DEPARTMENT OF THE ARMY
WILMINGTON DISTRICT, CORPS OF ENGINEERS
69 DARLINGTON AVENUE
WILMINGTON, NORTH CAROLINA 28403-1343

Action ID: SAW-2013-01833 (STIP Nos. I-4400/I-4700)

I refer to your permit modification request of October 18, 2022, to modify impacts to waters of the U.S. at two previously permitted sites (Sites 30 and 31) in the I-4700 portion of the I-4400/I-4700 project.

SPECIAL CONDITIONS
Revised ~~March 25, 2021~~ November 10, 2022
ACTION ID. SAW-2013-01883
NC DEPARTMENT OF TRANSPORTATION
I-26 WIDENING, HENDERSON AND BUNCOMBE COUNTIES
STIP NO. 1-4400/I-4700

PERMIT DRAWING SHEET 59 OF 97

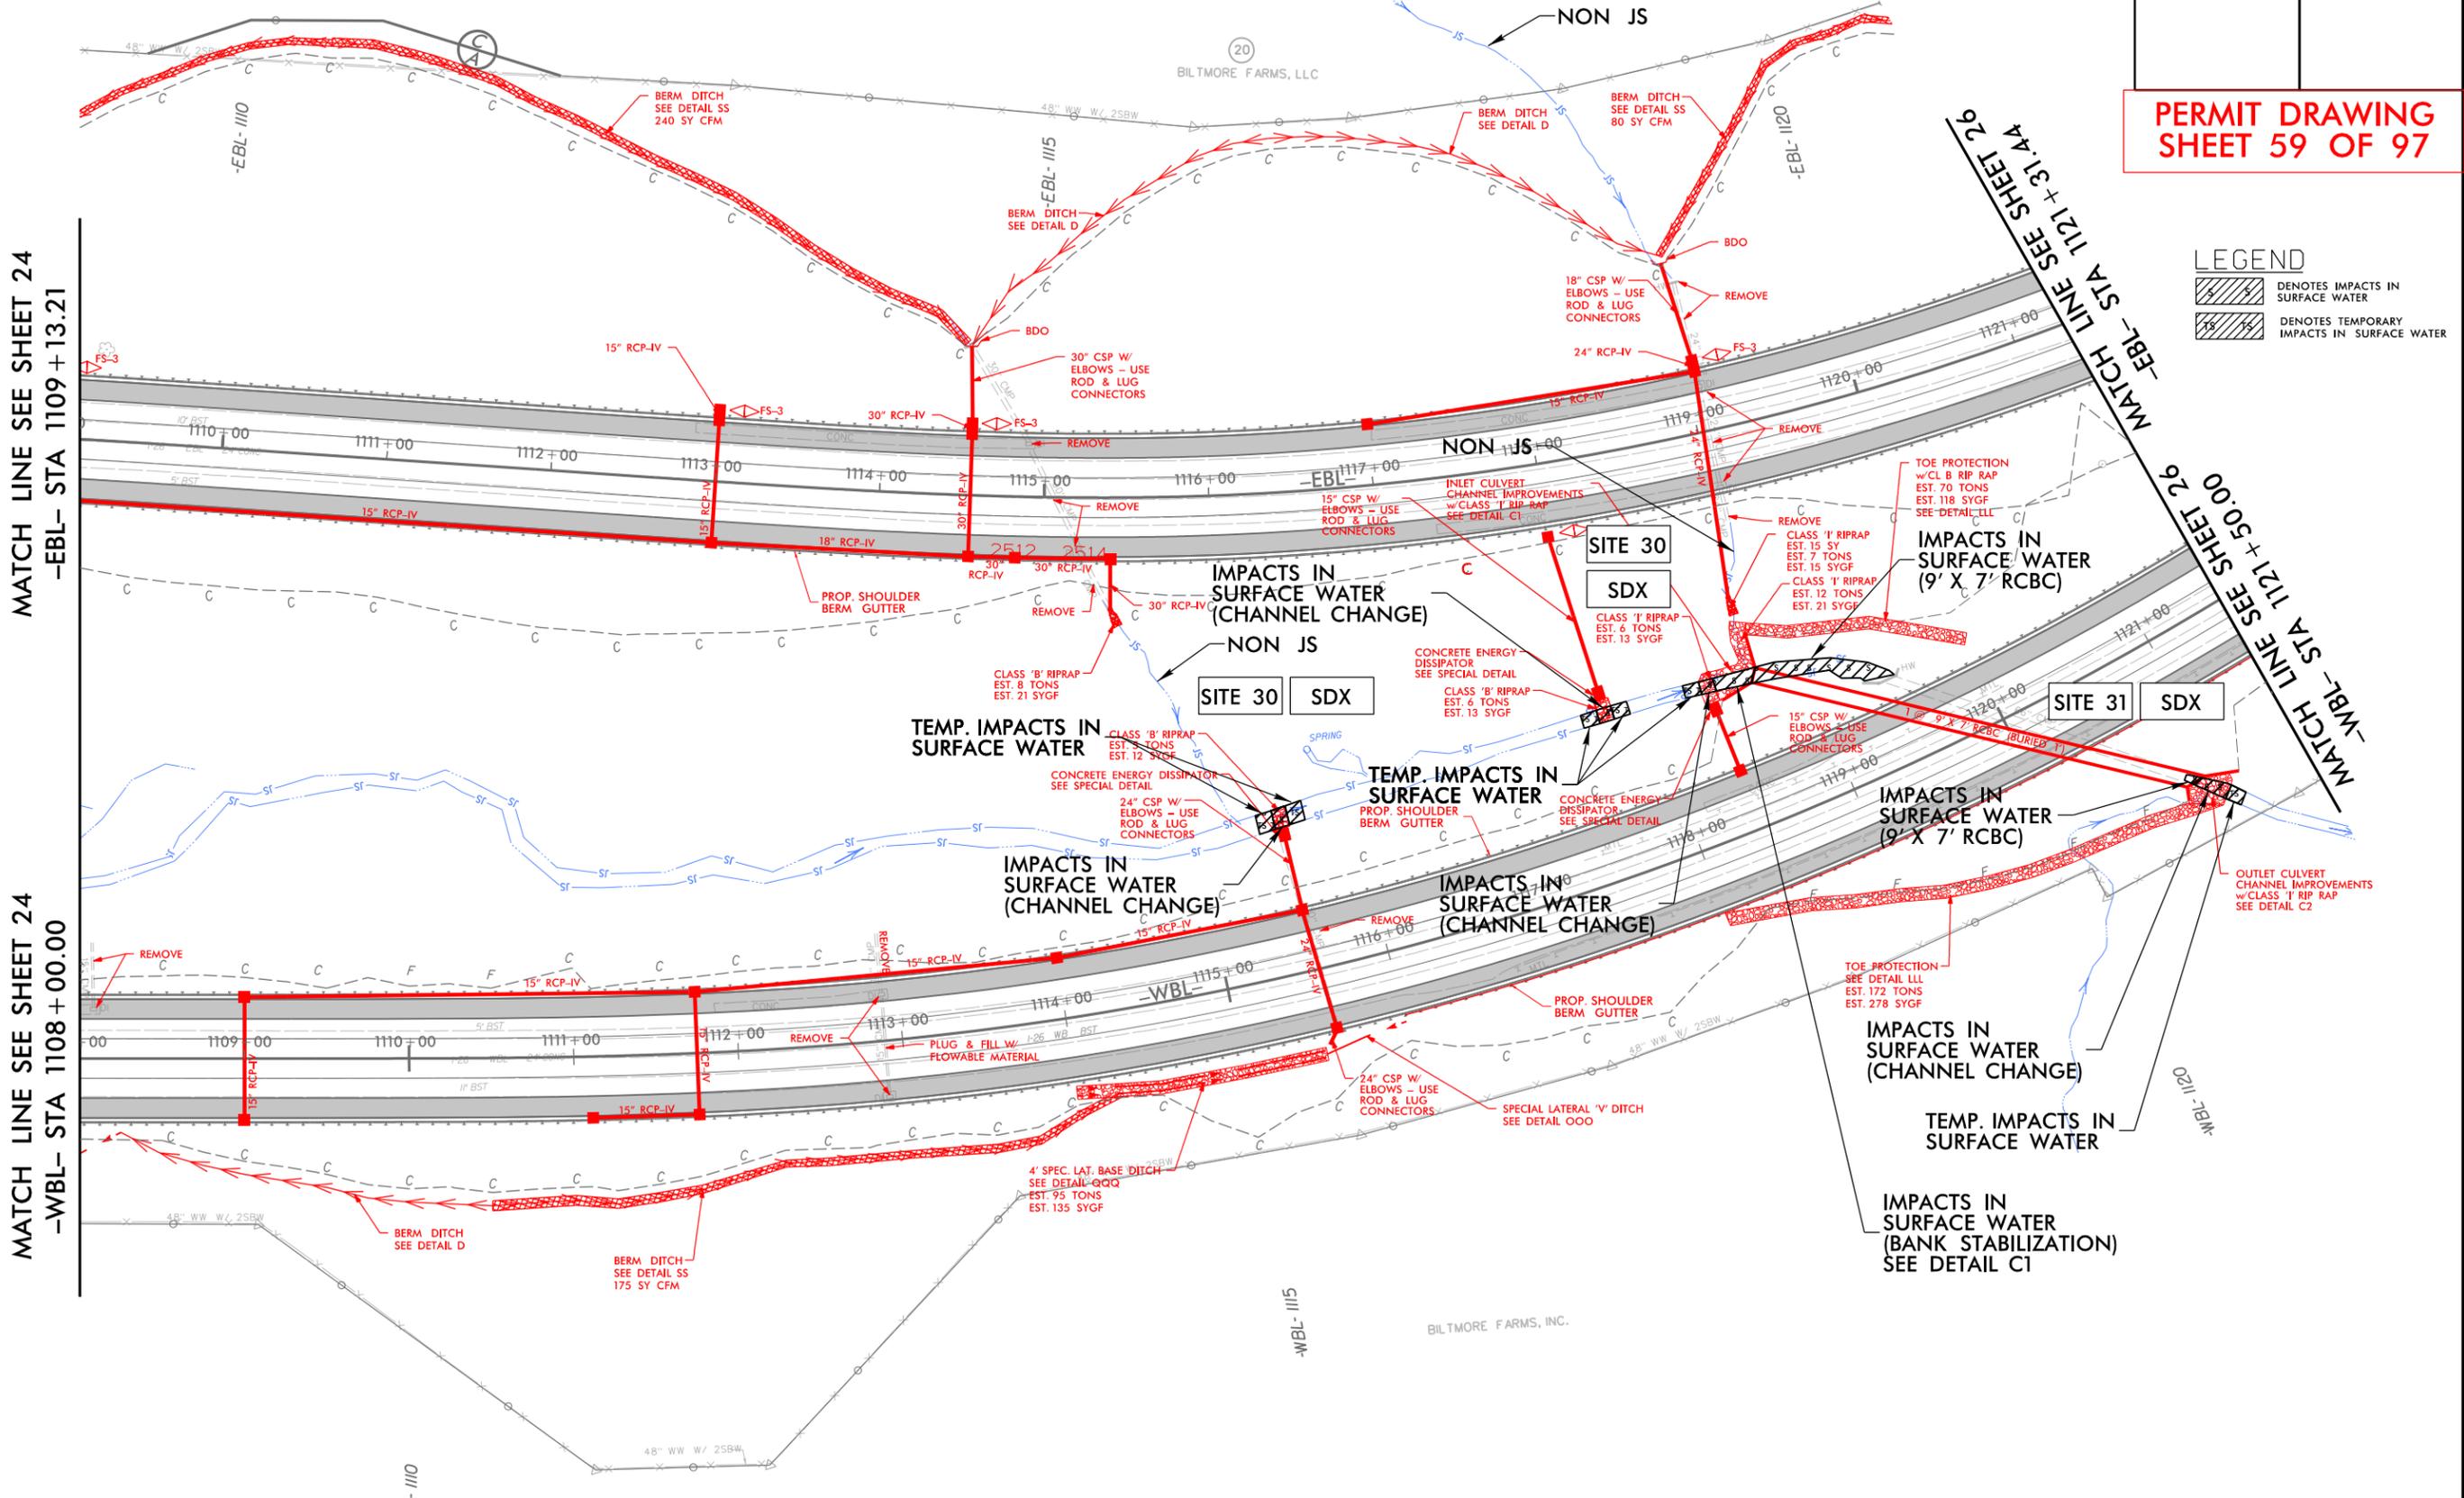
Site 30 – The existing 66” RCP would be replaced with a 9’x7’ RCBC and bank stabilization would be placed at this end of the culvert. This change would result in an additional 8 lf of permanent impact/loss (culvert) and 25 lf of permanent impact (bank stabilization) at Site 30. This change would also result in a reduction of previously authorized temporary impacts.

Site 31 –The new RCBC would be replaced, as described above, and there would be a new channel change (with embedded rip rap) at this end of the culvert. This change would result in a reduction of 30 lf of previously authorized permanent impact/loss (culvert) but would require 20 lf of new impact/loss from the channel change. The overall temporary impact amount would not change.

- “Wetland and Surface Water Impacts Permit, I-4700”, permit drawing sheets 1-97 (Phase 1), as revised by permit drawing sheets 2, 2A, 59, 60-62 of 97, revised on October 13, 2022, and sheet 63 of 97, revised on October 26, 2022.
- “Wetland and Surface Water Impacts Permit, I-4400 C”, sheets 1-43 (Phase 2)
- “Wetland and Surface Water Impacts Permit, I-4400 BB,” permit drawing sheets 1-83, dated August 6, 2019 (Phase 2).
